Well Name: MYSTERY AYM FEDERAL	Well Location: T20S / R25E / SEC 33 / NWSW /	County or Parish/State: EDDY / NM
Well Number: 1	Type of Well: CONVENTIONAL GAS WELL	Allottee or Tribe Name:
Lease Number: NMNM108454	Unit or CA Name:	Unit or CA Number:
US Well Number: 300153254100S1	Well Status: Gas Well Shut In	Operator: EOG RESOURCES INCORPORATED

Notice of Intent

Type of Submission: Notice of Intent	Type of Action Plug and Abandonment
Date Sundry Submitted: 06/04/2021	Time Sundry Submitted: 10:12
Date proposed operation will begin: 06/25/2021	
Procedure Description: Please see attached.

Revised P&A

Mystery AYM Federal 1 Current

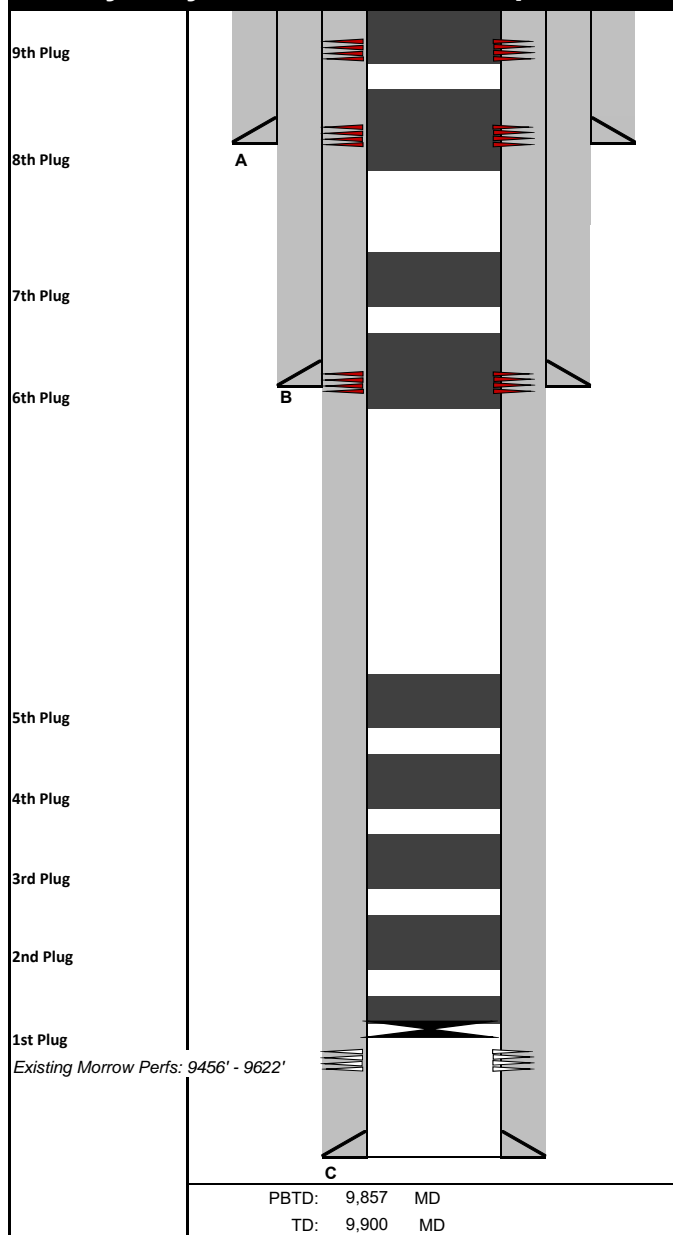
1. Set CIBP at 9444ft. Spot CI H cmt from 9444' - 9290'. (Pressure Test) **WOC & Tag(T/Morrow)**
2. Spot 25sx CI H from 9228'-9008'. **(T/Atoka)**
3. Spot 25 sx CI H from 8832'-8621'. **(T/ Strawn)**
4. Spot 25 sx CI H from 8302ft – 8615'. (T/ Canyon)
5. Spot 37 sx CI C from 6900' - 6700'. (T/Wolfcamp)
6. Spot CI C from 6600' - 5-6500'. (T/ 3rd BS)
7. Perf @ 3486'. Sqz 30 sx CI C from 3486'-3193'. **WOC & Tag (2nd BS)**
8. Perf @ 555' and Sqz 25 sx CI C from 555' - 704'. (T/San Andres)
9. Perf @ 100'. Sqz CI C from 100' – surface.
10. MLF between plugs- Above ground steel tanks will be utilized.
11. Cut wellhead off. Set Dry Hole marker.
